Contents

- Item 1. Upper Drive Belt Guard - Thunderbird All Models
- Item 2. Catalytic Converter Mounting Bracket Fixings - Thunderbird Commander and Thunderbird LT
- Item 3. Torque Figures Updates - Thunderbird All Models
- Item 4. Horn Fixing - Rocket III Touring ABS
- Item 5. Centre Stand Fixings - Trophy and Trophy SE
- Item 6. Front Brake Hose Clip - Rocket III Roadster ABS
- Item 7. Clutch Cover Kits - All Speed Triple models from VIN 210445; All Sprint ST and Sprint GT models from VIN 208167; All Tiger 1050 models from VIN 287504; Tiger Sport models from VIN 570059
- Item 8. Breather Cover Fixings - Tiger 800 and Tiger 800XC All Models
- Item 9. Audio System - Trophy SE

Description: Upper Drive Belt Guard

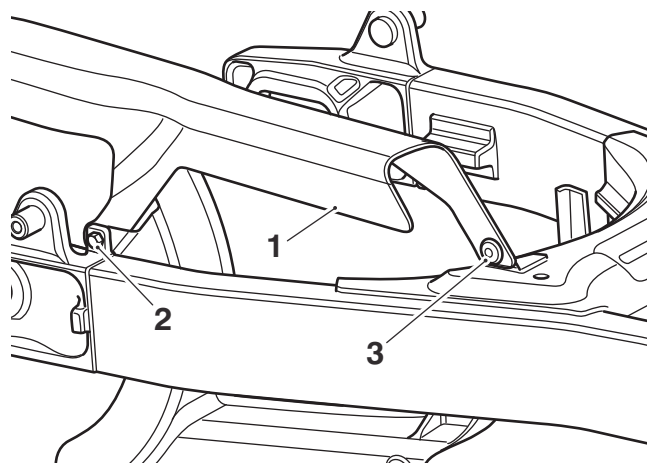
An encapsulated fixing has replaced the rear fixing for the upper drive belt guard on the above models and is retrofittable to all earlier models. The tightening torque remains at **10 Nm** and the fixing must be replaced if loosened or removed.

For models already in service, if the rear fixing for the upper drive belt guard has been removed, the encapsulated fixing (part number T3205064) must be fitted.

- **If loosened or removed for any reason, the fixing must be replaced.**

Description: Catalytic Converter Mounting Bracket Fixings

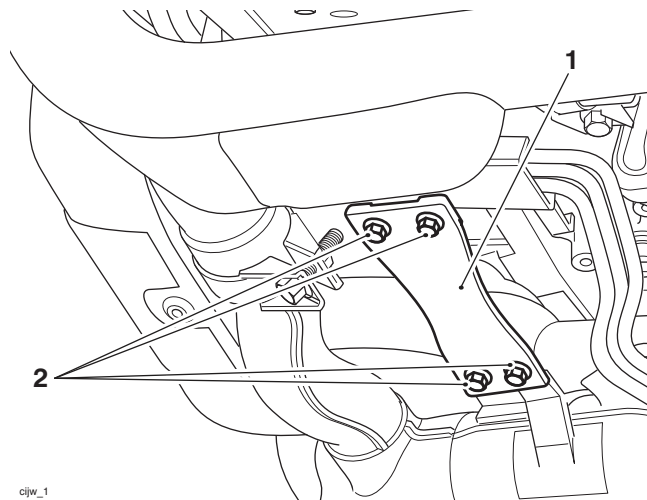
A copper based grease has been added to the fixings securing the catalytic converter mounting bracket on the above models. The tightening torque for the fixings has changed to **9 Nm** to coincide with the introduction of the copper based grease.

If refitting or replacing the catalytic converter mounting bracket fixings, apply a copper based grease to the fixings and tighten to **9 Nm**.

- **Models already in service need not be re-tightened unless the fixings have been loosened or removed.**

Description: Horn Fixing

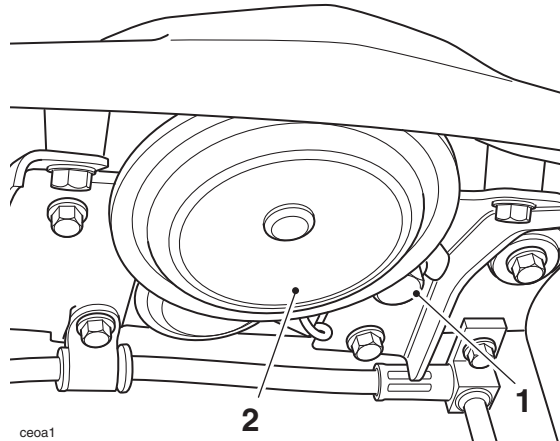
The torque figure for the horn fixing (mounted on the lower yoke) has changed to **27 Nm** on the above models.

- **Models already in service need not be re-tightened unless the fixings have been loosened or removed.**

Description: Centre Stand Fixings

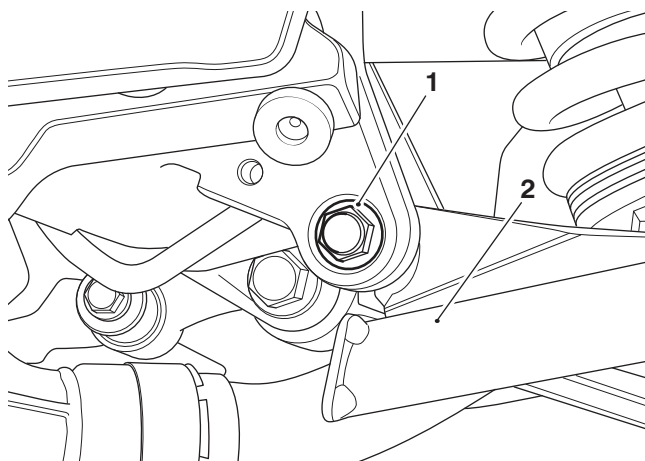
The torque figure for the centre stand fixings has changed to **70 Nm** on the above models.

- **Models already in service need not be re-tightened unless the fixings have been loosened or removed.**

Description: Front Brake Hose Clip

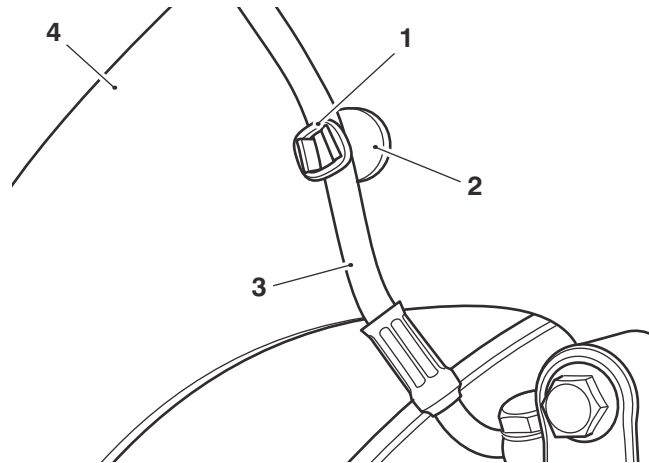
For the above model from VIN 637324, an O-ring has been introduced to secure the front brake hoses to their retaining clips on the front mudguard.

When assembling a new Rocket III Roadster ABS from VIN 637324, there will be two O-rings in the fixings kit that will need to be fitted as described below.

With the front brake hoses in their clips on the front mudguard, fit the O-rings around the outer lugs of the clips as shown in the illustration below.
